Safety Recall: Rear Door Latch Assembly

2000 Odyssey Ex:

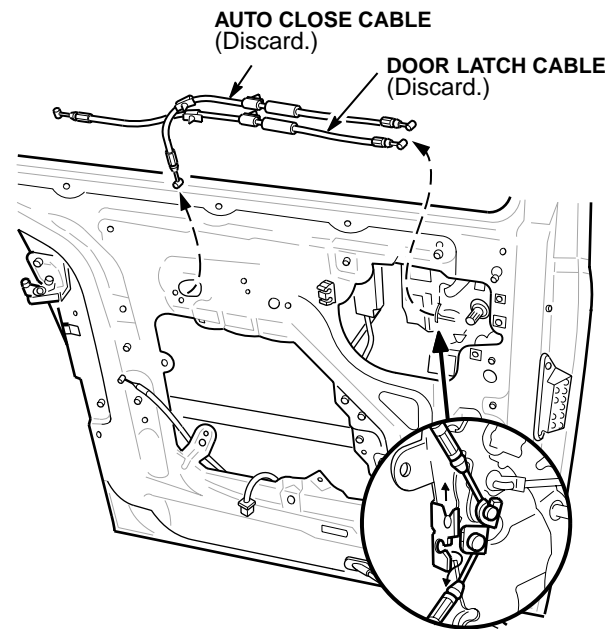
8. Disconnect the door latch cable and the auto-close cable from the door latch remote controller assembly. Discard the cables.

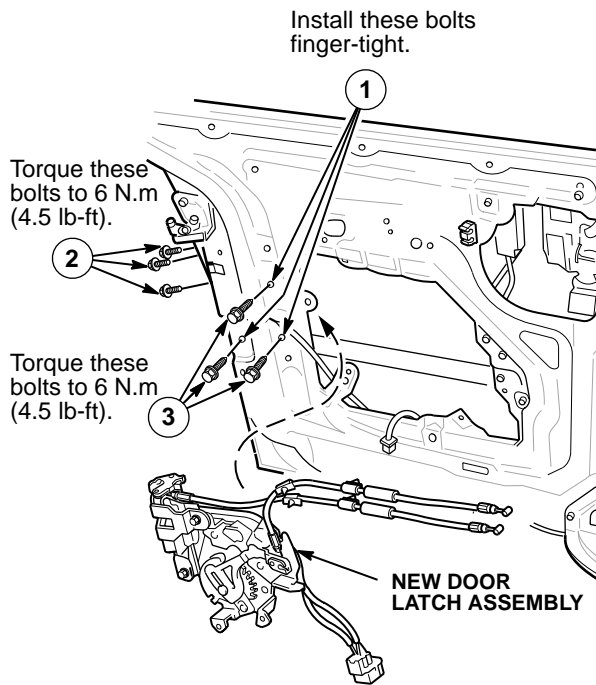
9. Connect the lower roller lever cable to the new door latch assembly.

10. Install the new door latch assembly in the door.
